# **8XC196NT SPECIFICATION UPDATE**

Release Date: October, 1996

Order Number 272865-002

Figure 1. ICC, IDLE versus Frequency

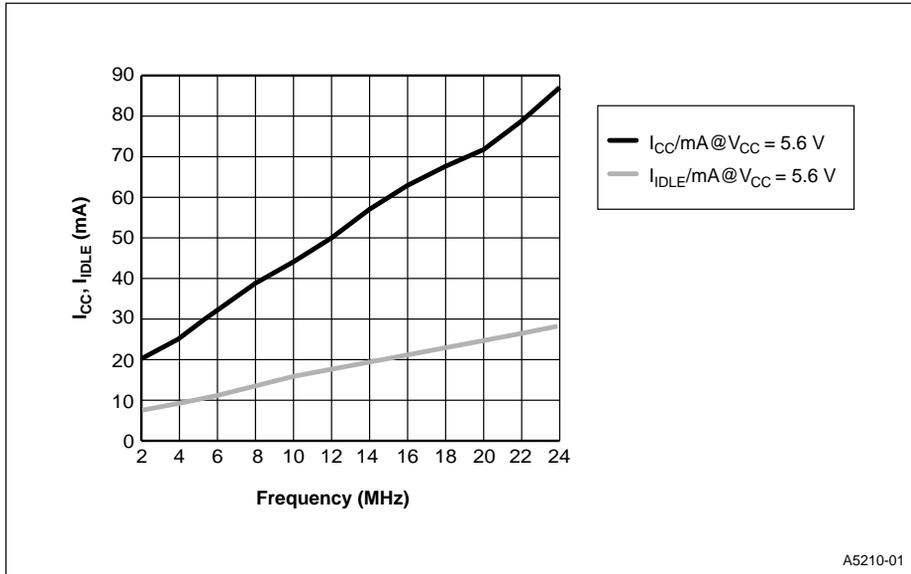
### 001. *ICC, IDLE versus Frequency*

**ITEM:** The following graphic illustrating ICC and IDLE versus Frequency will be added to the next revision (-005) of the 8XC196NT CMOS Microcontroller datasheet.
